Milesight_Release_Note_For_Camera_4X.7.0.70

Firmware Version: 4X.7.0.70

Applicable Model: MS-CXXXX-B

Release Date: 14th May, 2019

Figure 1 Privacy Mask Setting page

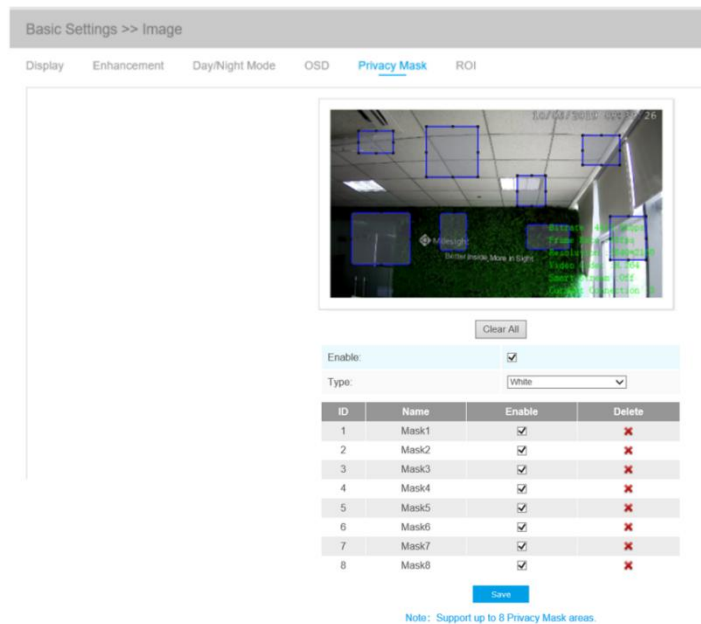
- (2) Support up to 8 **Privacy Masking** areas;

Figure 2 ROI Setting page

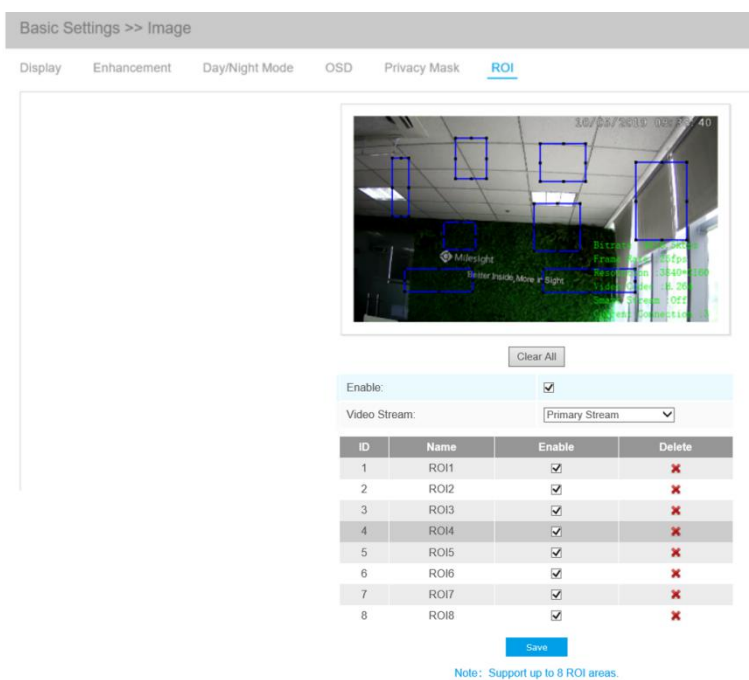
- (3) Support up to 8 **ROI** areas;

Figure 3 NAS Child Directory

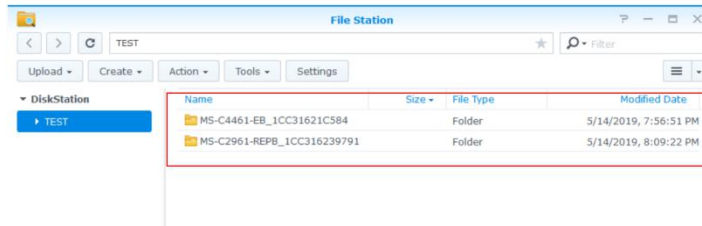
- (4) Support NAS to generate child directory;

Figure 4 PTZ - Status page

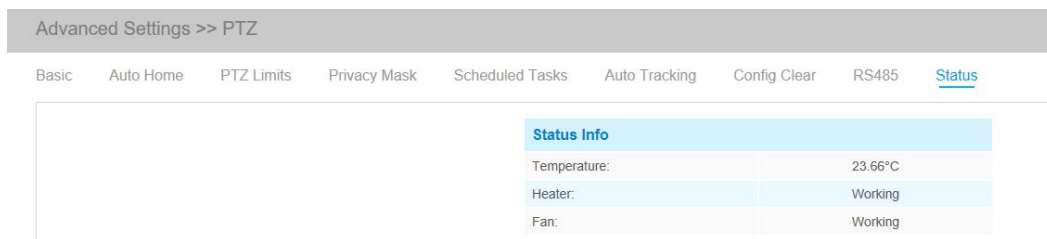
- (5) Support to **display temperature information** in “Advanced Settings - PTZ - Status” interface on Speed Dome Network Camera;

Figure 5 Basic Settings - Video Settings page

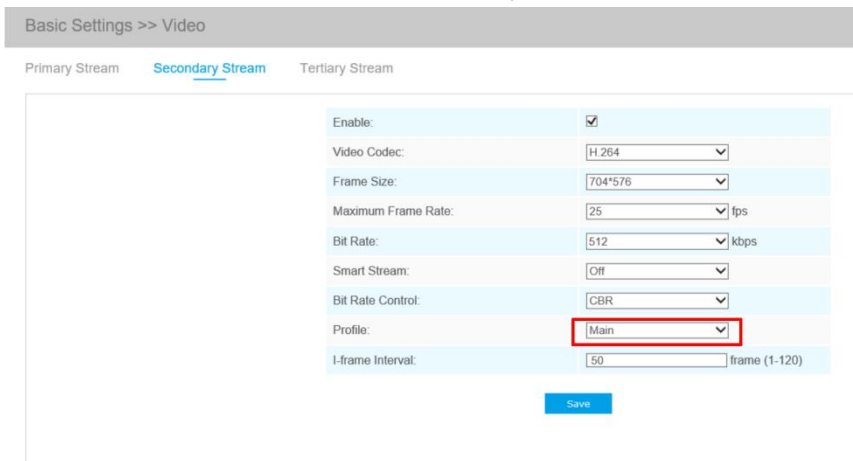
- (1) Support to remember the status of zoom level before the restart on 12x AF Motorized Pro Bullet Network Camera or AF Motorized Mini Dome Network Camera;
- (2) Optimize **upgrade mechanism** and improve upgrade efficiency;
- (3) Optimize CGI such as device names can support spaces character;
- (4) Optimize that default Profile of H.264 as Main on Secondary Stream.
